**ENCLOSURE 2**  
**RESPONSES TO EPA QUERIES**

## **Moolarben Coal Complex – Open Cut Optimisation Modification**

### **Response to NSW Environment Protection Authority Supplementary Submission**

**Figure 3.1.2 – Reproduced from the ANZECC Guideline**

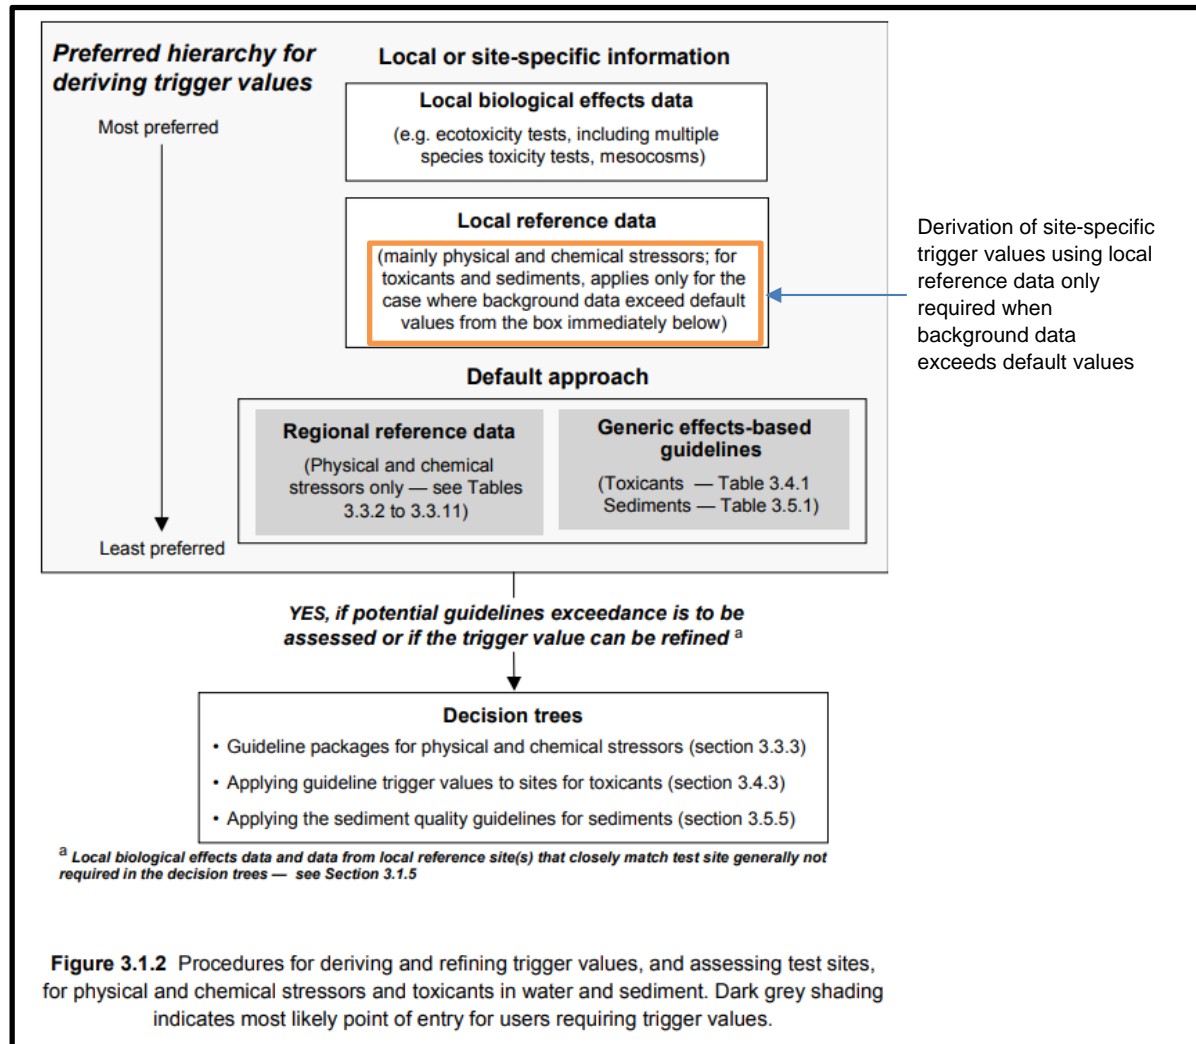
*The RTS proposes a selective approach to deriving trigger values whereby the site-specific trigger value is proposed when it is less than the default trigger value and the default trigger value is proposed when it is less than the site-specific trigger value. This approach is inconsistent with the ANZECC methodology (see Figure 3.1.2 in ANZECC 2000).*

The EPA's statement is not correct.

The approach to metal concentration limits in the RTS is consistent with the process described in the Australian and New Zealand Environment and Conservation Council (ANZECC) (2000) *Australian and New Zealand Guidelines for Fresh and Marine Water Quality* (ANZECC Guideline), whereby the "guideline trigger value" is preferentially adopted, as these "represent the best current estimates of the concentrations of chemicals that should have no significant adverse effects on the aquatic ecosystem" (as described in the ANZECC Guideline).

Figure 3.1.2 of the ANZECC Guideline is reproduced below, and clearly states the use of local reference data (i.e. derivation of a site-specific trigger value) "*applies only for the case where background data exceed default values from the box immediately below*" (emphasis added).

The "*box immediately below*" refers to Table 3.4.1 of the ANZECC Guideline. All of the proposed concentration limits for metals proposed in RTS (refer to Table 4 of the RTS) are based on the guideline trigger values specified in Table 3.4.1 of the ANZECC Guideline, with the exception of aluminium, where the background data exceeds the default guideline trigger value.

Figure 1. Predicted water table pattern and flow directions 100 years after completion of mining

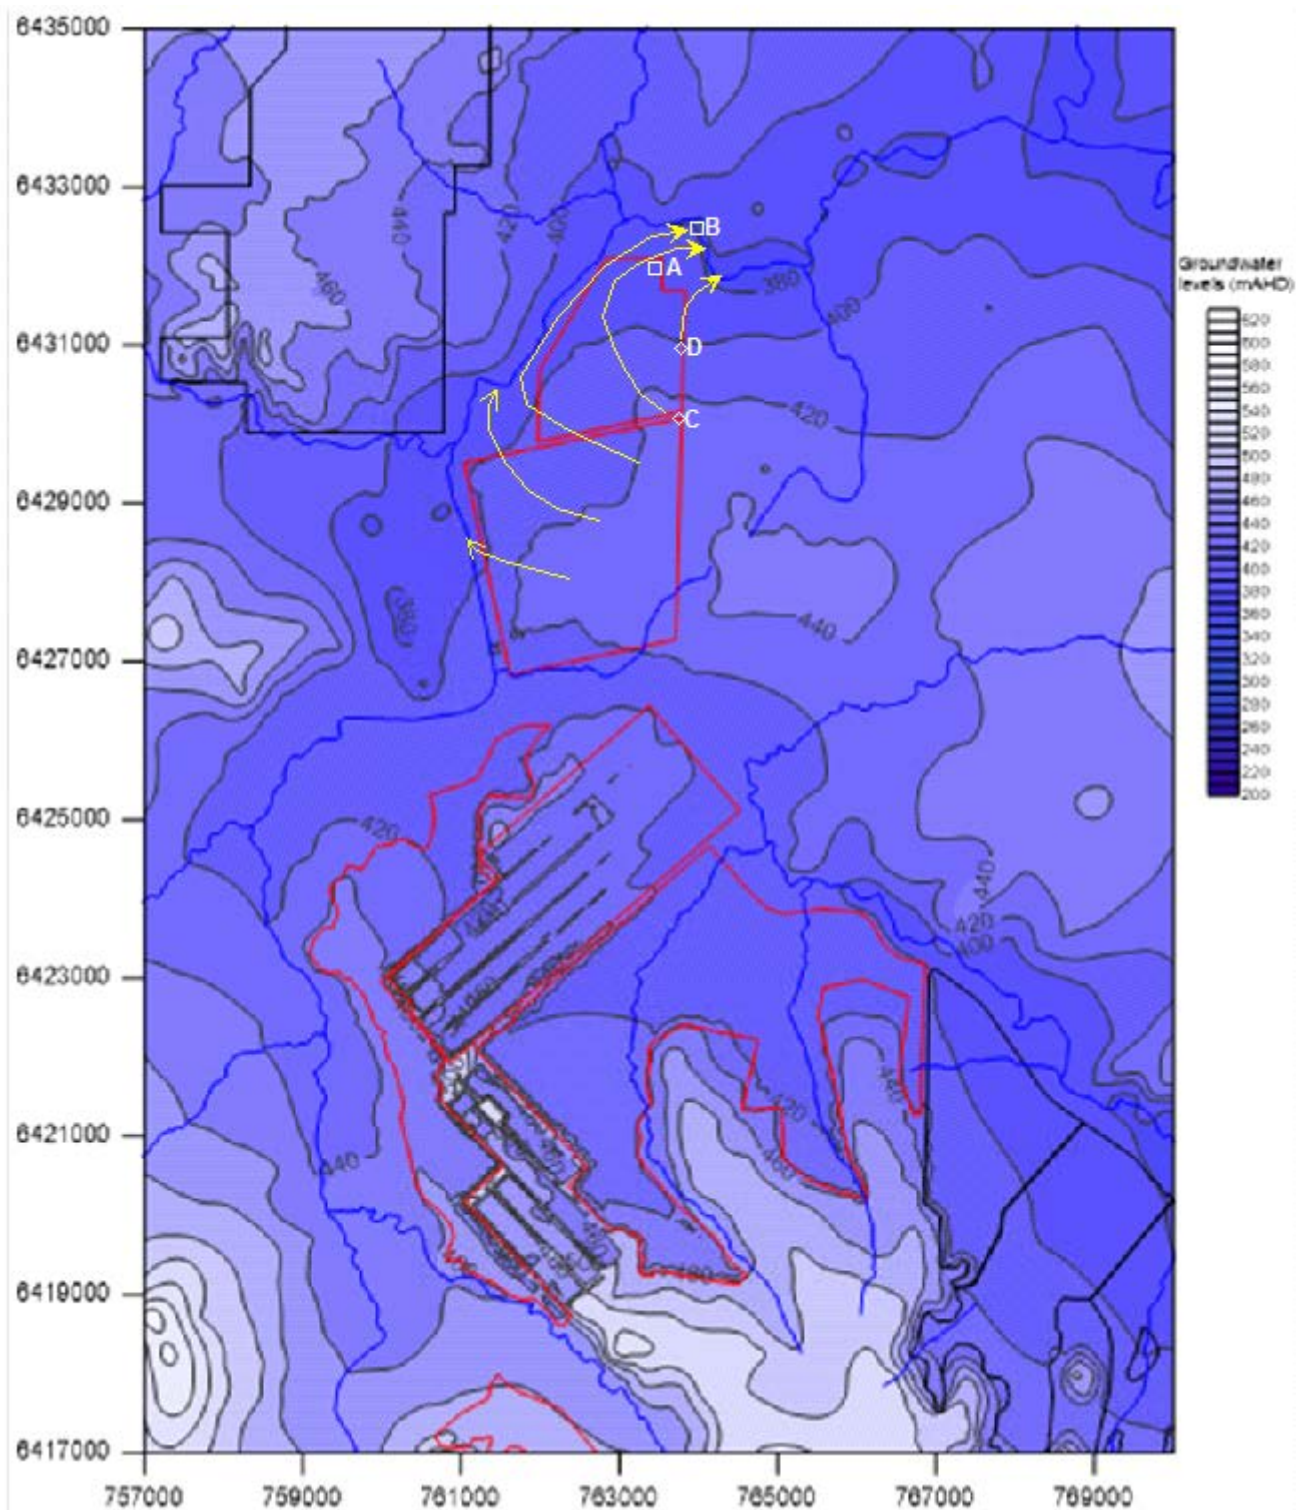
The EPA considers diffusion has been omitted as a key solute transport process.

To assist in provision of an informed opinion, we have interrogated the groundwater model to give groundwater head patterns at the water table (**Figure 1**) and the Ulan Seam (Layer 9; **Figure 2**) at 100 years after completion of UG4 mining, and an approximate water table profile across UG4 from the Goulburn River Diversion at the Ulan Mining Complex East Pit to Saddlers Creek (**Figure 3**).

**Figure 1** shows that long-term groundwater flow at the level of the water table would follow arcuate paths across the UG4 footprint towards the Goulburn River to the east, near site B. The approximate path lengths from key sites are:

- From site A: 0.7 km
- From site D: 1.1 km
- From site C: 3.3 km.
